SAFETY RECALL

2019 CRF450L HORN STAY BROKEN

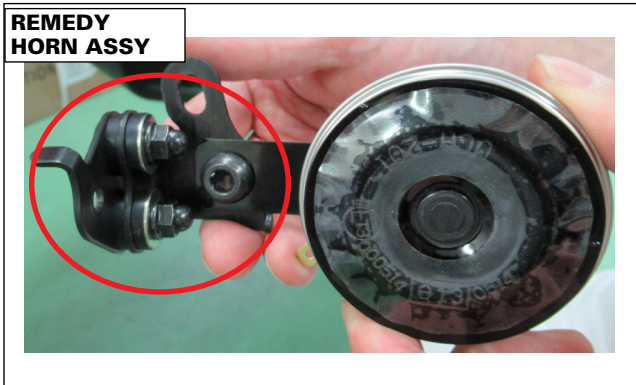
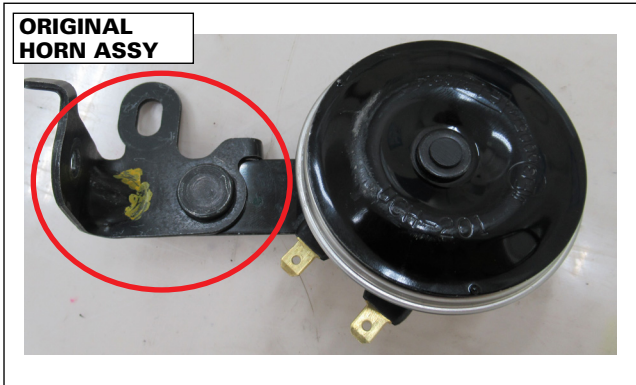
Before performing the recall repair, inspect the motorcycle's horn assembly to determine if the repair has already been performed.

- If the **remedy** horn assembly (shown below) is currently installed, the recall repair has already been performed. No repair is needed.

- If the **original** horn assembly (shown below) is currently installed, the repair needs to be performed. Continue to the Recall Repair Procedure section.

Refer to page 20-23 in the 2019 CRF450L Service Manual to perform the recall repair by replacing the original horn assembly with the remedy horn assembly.

NOTE: There are two new clips for the horn harness included in the remedy parts kit. Use these clips to replace the original clips, if damaged.
